**BLACKWATER RIVER
BRIDGE**

REFERENCE MILE 492 MACKENZIE HIGHWAY

**DEPARTMENT OF PUBLIC WORKS
EDMONTON, CANADA**

**BASIC ENVIRONMENTAL DATA
BLACKWATER RIVER BRIDGE
REFERENCE MILE 492**

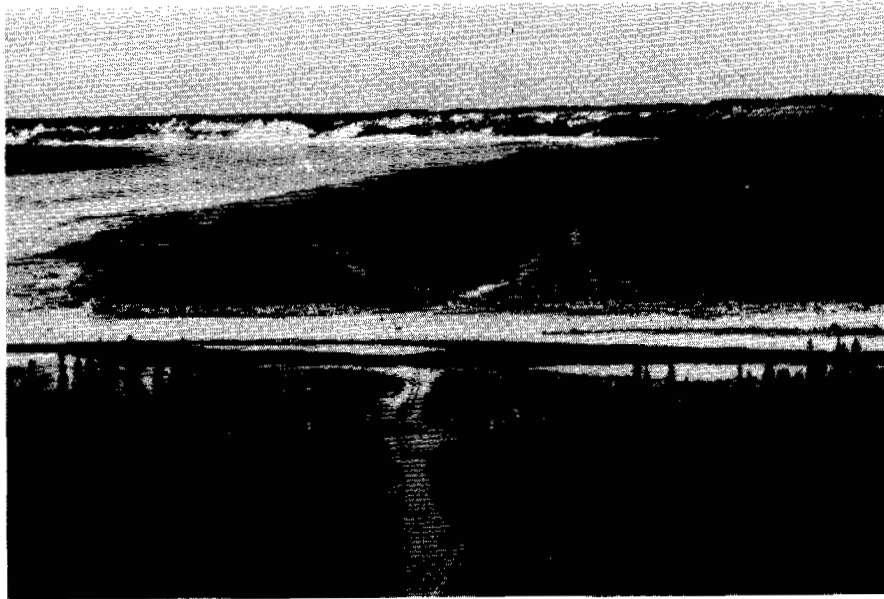
29.10.72. Blackwater River looking north. Extensive fill and erosion protection structure will considerably modify existing terrain. Bridge site plans also recommend removal of active alluvium which should be reconsidered.
